DEFENSE LOGISTICS AGENCY  
DEFENSE NATIONAL STOCKPILE CENTER  
8725 JOHN J. KINGMAN ROAD, SUITE 3229  
FT. BELVOIR, VIRGINIA 22060-6223

Re: License STC-133  
Docket: 040-00341

SUBJECT: Request For Additional Information Concerning Application For Amendment To License, Control No. 136268

In reference to your letter of July 20, 2005, the Defense National Stockpile Center (DNSC) submits the enclosed additional information concerning the Final Status Survey Report (FSSR) for portions of the DNSC Scotia depot in Scotia, New York dated December 2004.

**Alpha Quantile Plot; SU 1 Scotia**

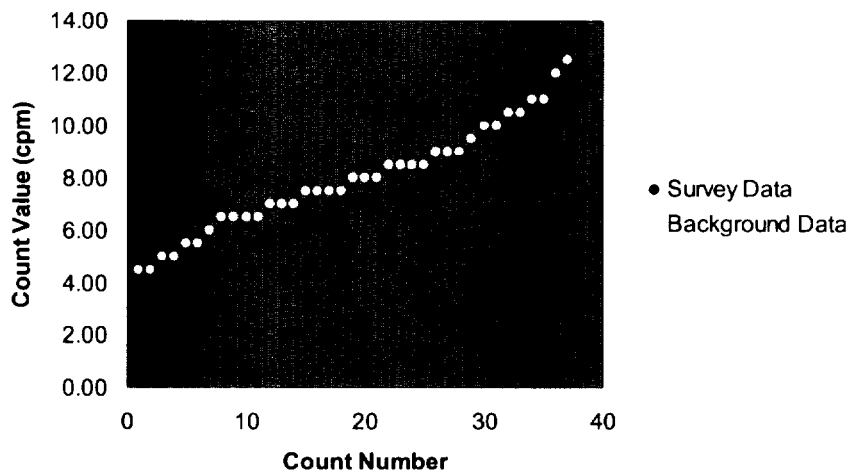
- 2.a.ii. Explain the basis for using the combined number as the “background” and subtracting it from the measurements, rather than using the Alternate Null Hypotheses to demonstrate that the areas are “indistinguishable from background” as recommended in MARSSIM for areas where there is high variability in the background.

Two of the three background areas for OA 300 did not vary from each other as your calculations showed (8.4 cpm and 8.6 cpm respectively). Only the one area to the west of the fence caused a variation. This does not indicate the need for using scenario B as the mechanism of release. The background data sets from the two locations within the fence (locations 31-90) correlate well with the data obtained from the survey unit providing a good indication that there is no residual radioactivity at the site. We did reanalyze the OA 300 survey data eliminating the first 30 data points. This reduces the average alpha background from 9.6 cpm to 8.5 cpm with data ranging from 4.5 – 12 cpm. The average gross count rate in the survey unit was 6.0 cpm and ranged from 1.2 – 10.3 cpm. Using this average to subtract from the survey data does not change the final results.

These two ranges overlap and do not show a significant difference. Below is a quantile plot of the two data sets. Note that the slope of each line is similar and that the two data sets intersect. This indicates that the two data sets are similar and the background data may be used to evaluate the survey unit data. It also clearly points out that there is not residual radioactivity in the survey unit.

**Alpha Quantile Plot; SU 1 Scotia**

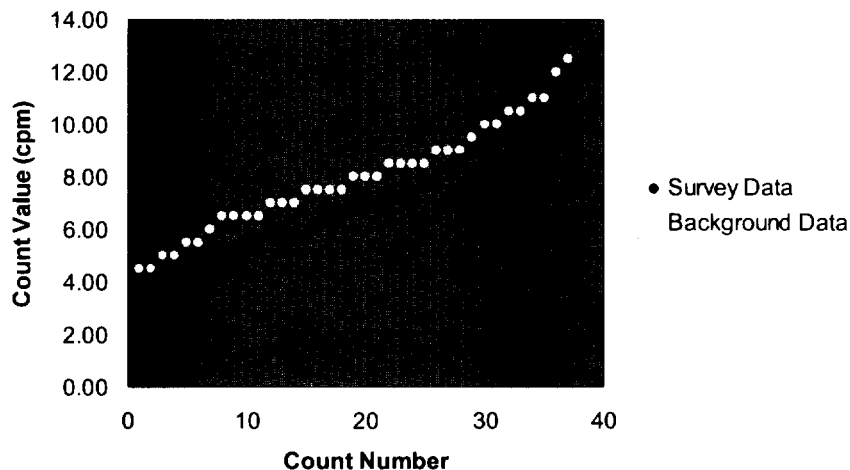
2.a.iii. *Explain why Survey Unit 1 measurements were significantly lower than the measurements made in areas which were considered to be unaffected (background areas).*

While there is a difference between the averages, we do not agree with that difference as being characterized as significant. As stated in the response above, the pad where the background and survey unit measurements were taken is one continuous pad and therefore made of the same

constituents. This, according to MARSSIM, is ideal for obtaining background measurements. On the surface there is no obvious reason for the differences in the data groups.

The cause of the difference could be weather related. The background data were collected on August 13, 2003. Surveys began at 0700 with the western location (locations 1-30) and finished at 1230 at the southern location (locations 61-90). The weather for the previous day and during the day the survey was performed was cloudy with thunder storms nearby. It is possible that the data collected the background was affected by radon buildup.

The range of the data points from the 2 background survey locations was 4.5 – 12.5 cpm. The range of data points from the survey unit was 1.3 – 10.3 cpm. These two ranges overlap well and do not show a significant difference. Below is a quantile plot of the two data sets. Note that the slope of each line is similar and that the two data sets intersect. This indicates that the two data sets are similar and that there is not residual radioactivity in the survey unit.
